PUNCH ITEM / P-024 / V1

Raise garage GFCI rough-in before wall close-in

Cooper Residence Renovation / CR-2026-017 / Residence / Garage / East wall / Entry door

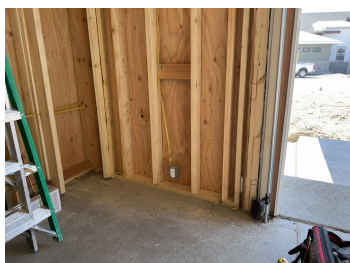
GFCI box centerline measures 12 inches above finished floor at the garage east wall.

Relocate the box so its centerline is at least 18 inches AFF before gypsum board installation.

Garage east wall context

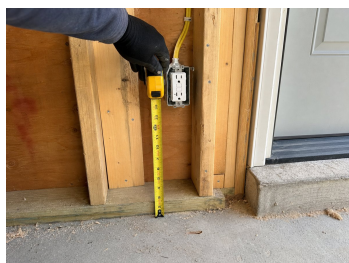
E1.1 Electrical Note 3 requires garage receptacle centerline at a minimum 18 inches AFF.
